ALERT SERVICE BULLETIN

SUBJECT: MAIN ROTOR DRIVE - Main Gear Box (MGB)

**Periodic check of MGB magnetic plugs,
and replacement of MGB planet gears**

Revision No.	Date of issue
Revision 0	2017-06-13

3.B.2. Check of MGB magnetic plugs

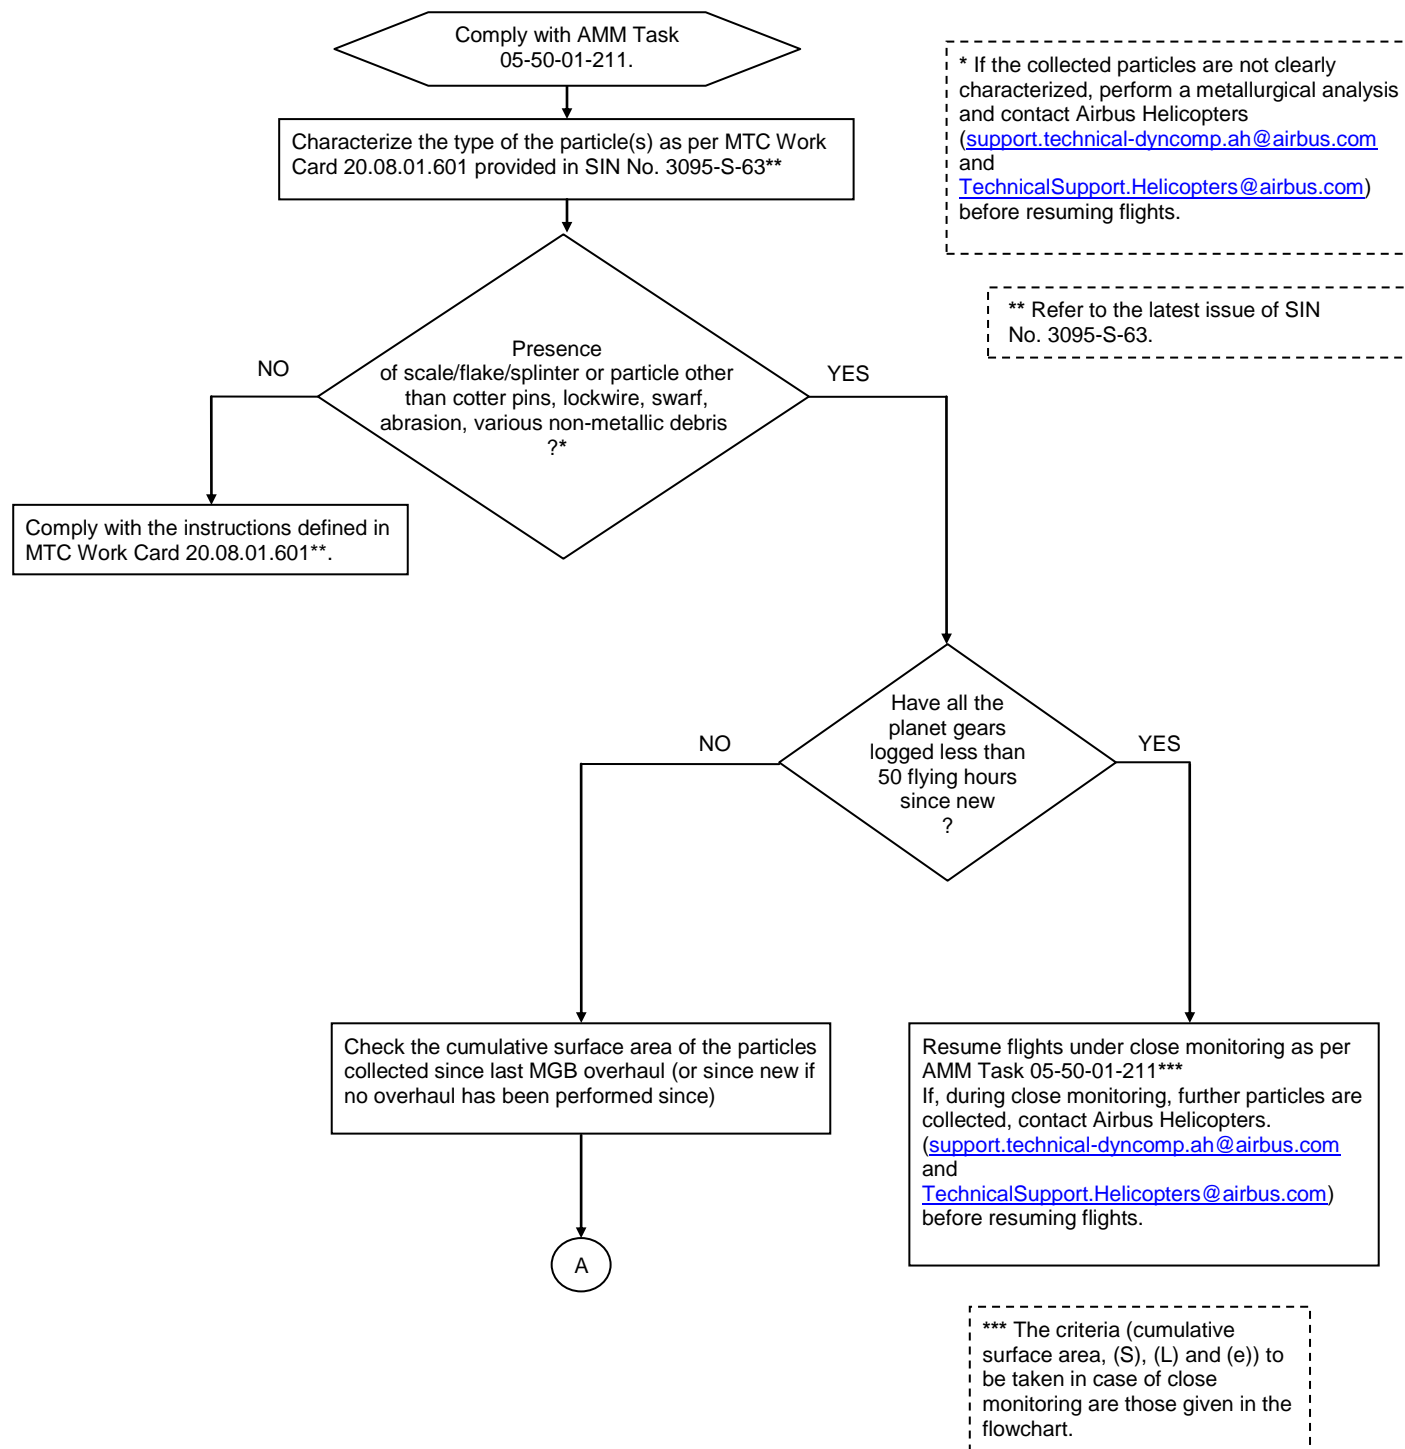
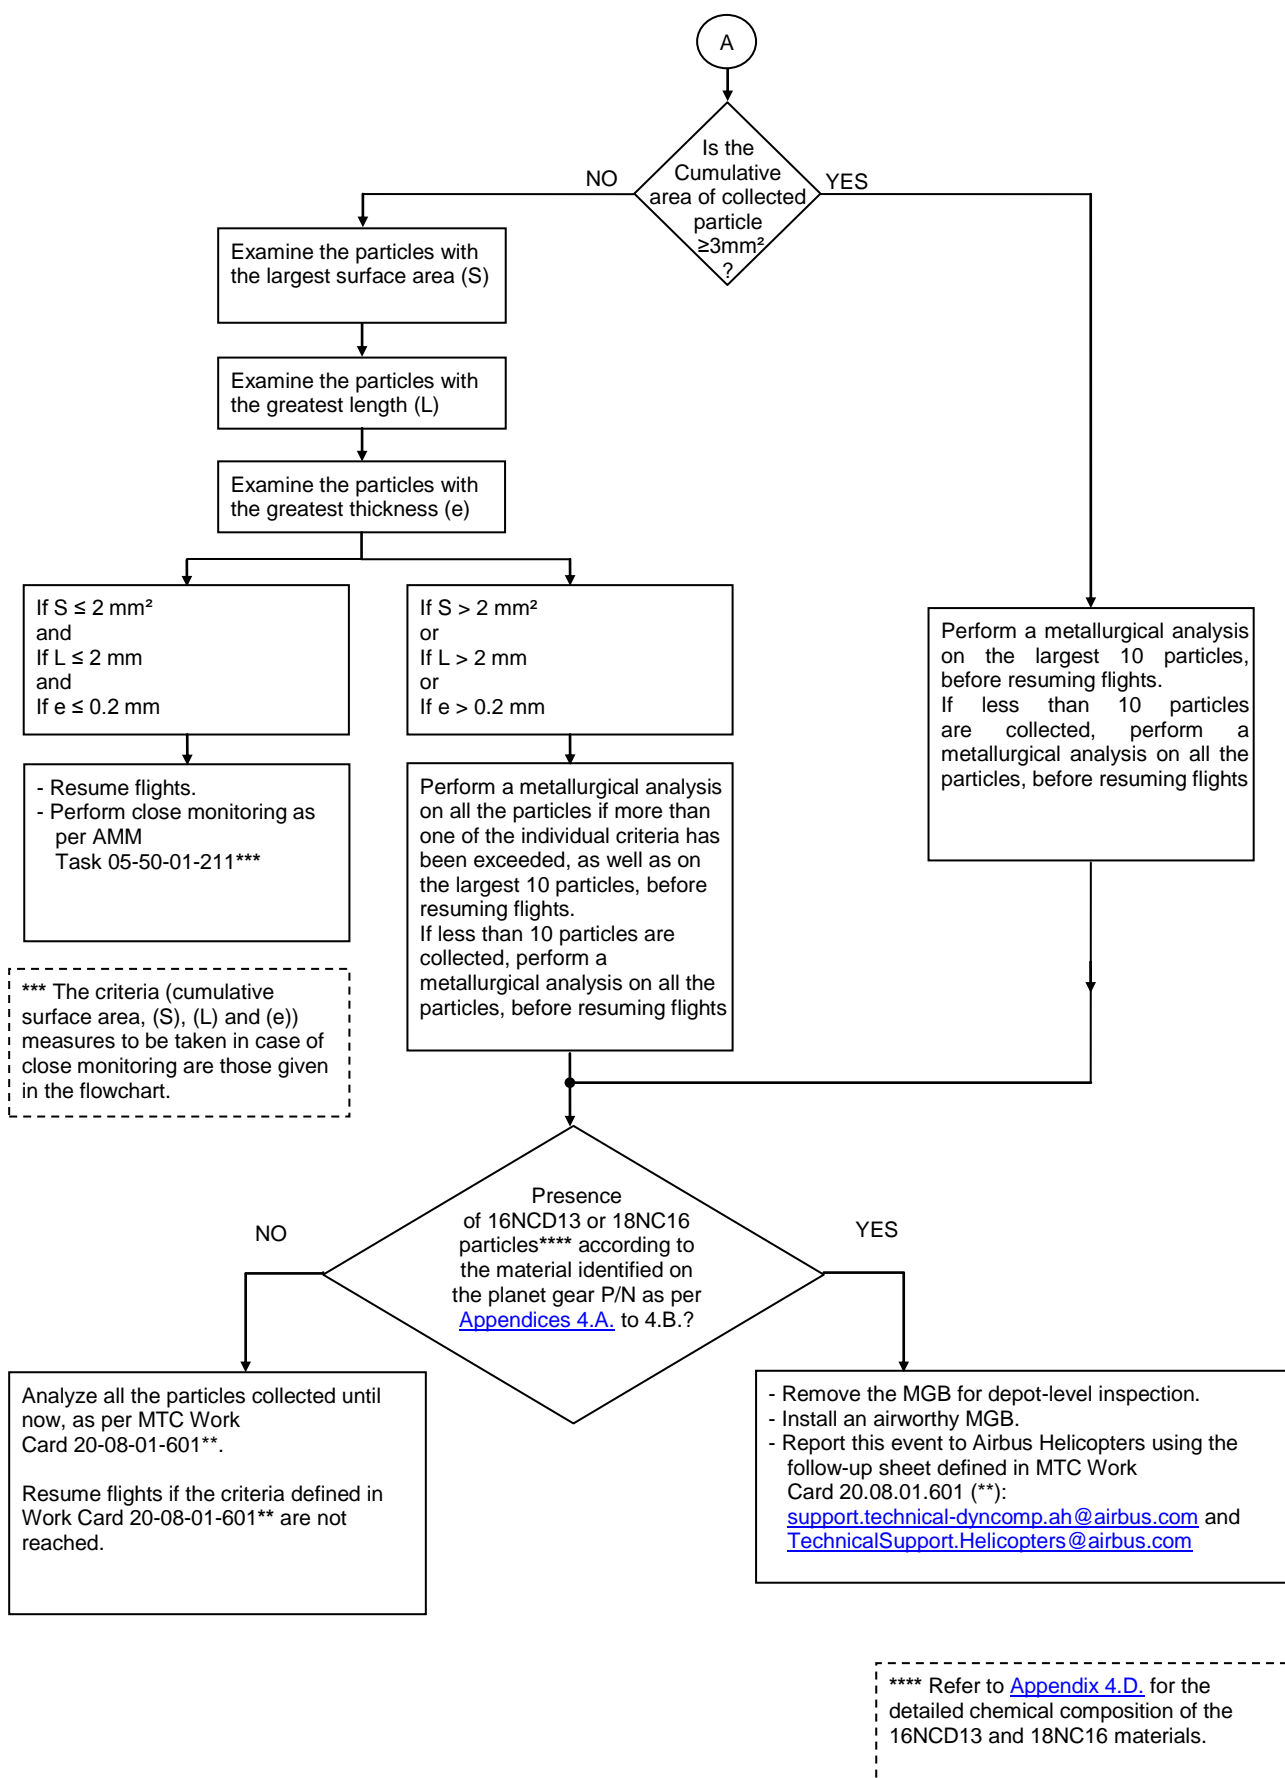
Check that there are no particles on the two magnetic plugs at the lower part of the MGB, as per AMM Task 63-40-02-211.

- a) If there are no particles:
 - Install the magnetic plug and resume flights.
- b) If there are particles:
 - Refer to the following flowchart.
